Review of GPS proposed by PWC and associated changes to NT technical regulations

Utilities Commission of the Northern Territory

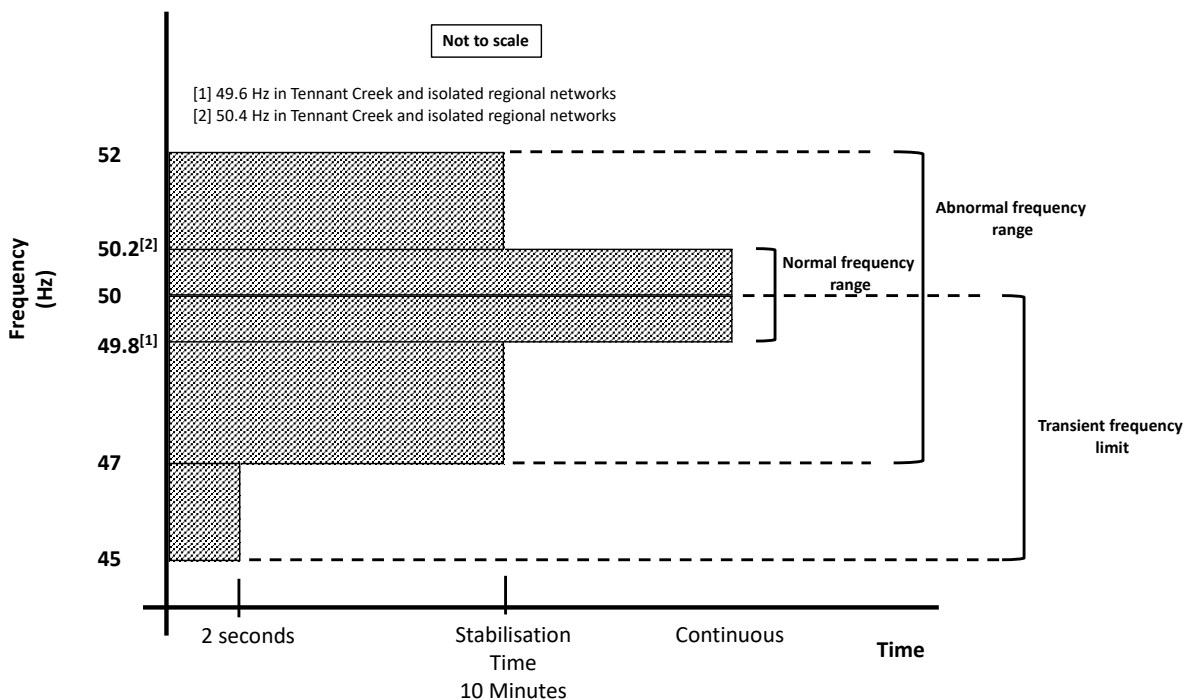
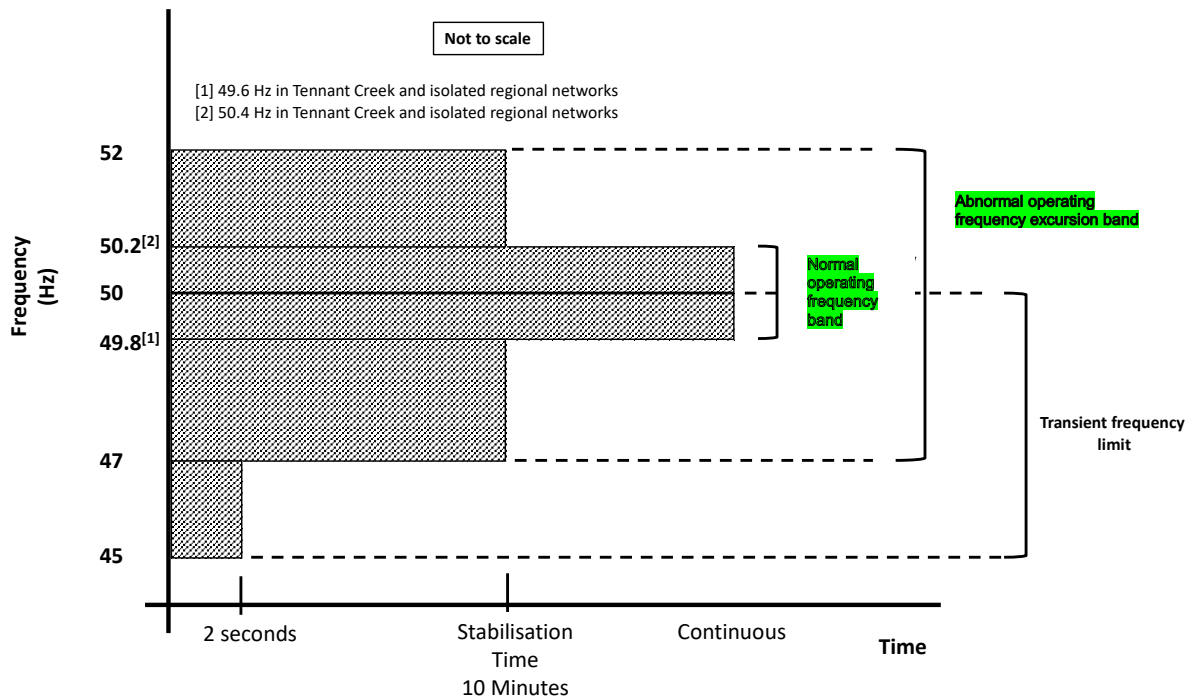
- stabilisation time is not defined in the frequency operating standard which according to the glossary is defined in clauses 2.2 and 2.4 on the NTC. The definition of stabilisation time should be amended to clarify that it is 10 minutes.
- RoCoF is not specified with any time dimension making the requirement more onerous than the automatic access standard specified in the NER NT. The NER NT automatic requirement specifies generators ride through RoCoF of +/- 4Hz/s for 0.25s and +/- 3Hz/s for 1s. The Western Australia South West Interconnected System (SWIS) GPS reforms are seeking to establish similar RoCoF requirements to NER NT. The AEMC review identified some thermal generators may not be able to meet these requirements and the minimum limits in the NER NT and proposed SWIS GPS recognize that by setting less onerous limits of +/- 2Hz/s for 250 ms and +/- 1Hz/s for 1s.

stabilisation time means the longest times allowable for the *frequency* of the *power system* to remain outside the normal operating frequency band, for any condition (including an “island” condition) in the *frequency operating standards* that apply to the *region* in which the *generating unit* is located. **The stabilisation time is 10 minutes.**

Figure 6.5: Forecasting accuracy, worst error

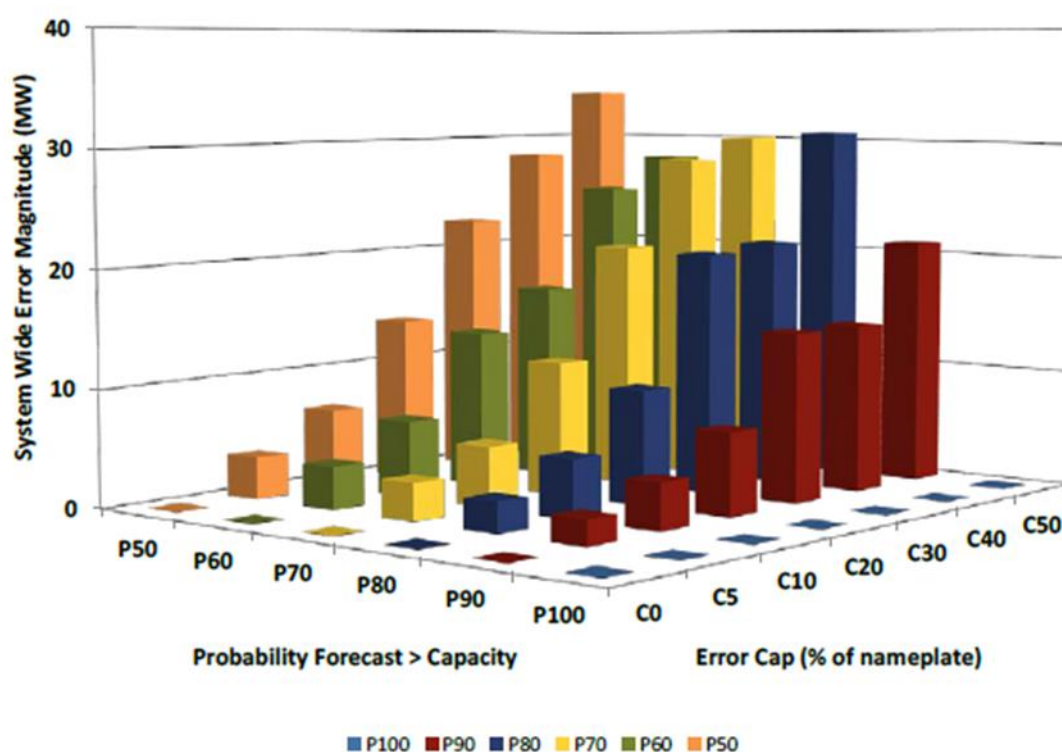
Figure 6.5 shows the system wide error that was simulated for different levels of solar forecast accuracy.

The proposed accuracy standard would deliver 90% of periods where forecast capacity is less than the actual capacity and a maximum error of 5% between the forecast and actual solar capacity. Table 2.1 indicates that forecast accuracy is estimated to breach the SSG about 1.5% of the time that solar generators are producing power. Figure 6.5 suggests the specified forecast accuracy will result in a system wide impact of a few MW.

Figure 4 - Power Supply / Demand Mismatch vs System Demand and Unregulated Frequency Impacts

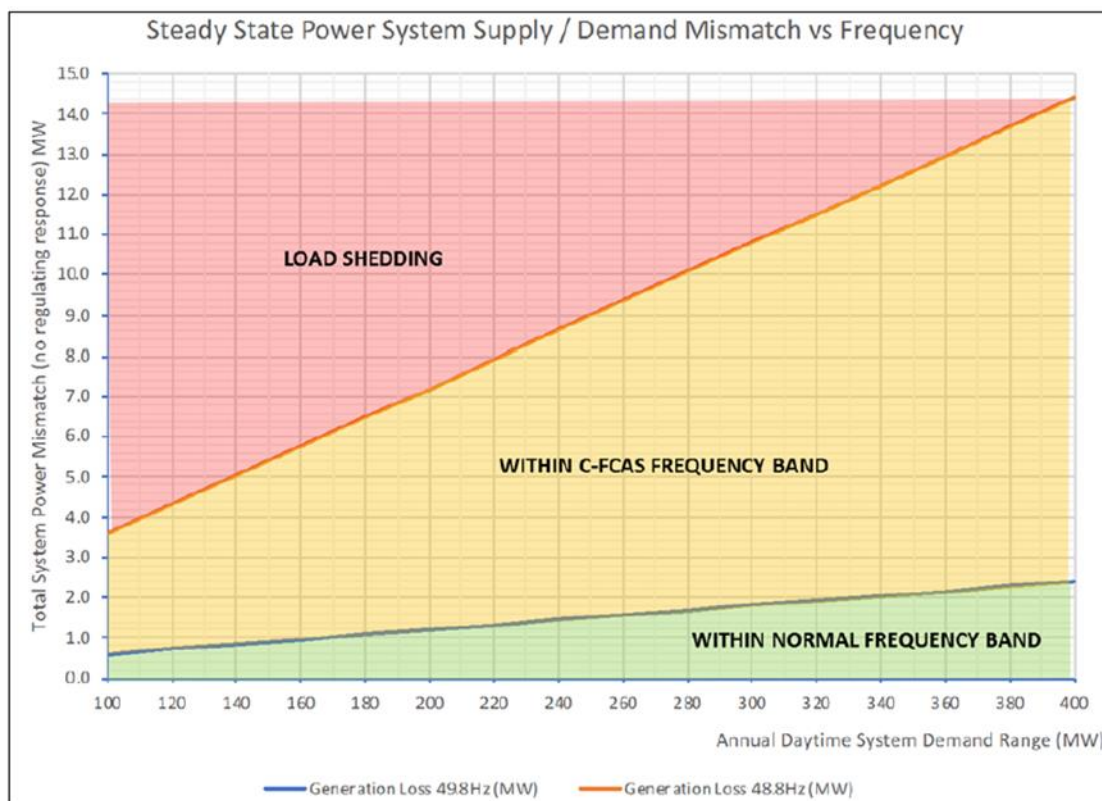
Figure 4 was extracted from the supplementary consultation paper developed by PWC in March 2019, titled “framework for the future”. The figure presents an analysis of the size of imbalance between load and generation that could breach the frequency operating standard assuming no governor response. It shows that an imbalance of less than 3.75 MW, with no governor response available should not give rise to load shedding. This means that a cloud cover event that causes a net generation reduction of less than 3.75 MW

and occurs concurrently with a generator contingency should not give rise to load shedding. 3.75 MW aligns with the level of system wide error shown in Figure 6.5 for a solar forecast accuracy requirement achieving 90% of forecasts below the actual capacity and a maximum forecast error of 5%. This suggests that these accuracy requirements may be appropriate if cloud cover events are likely to align with generator contingencies in the NT power systems.
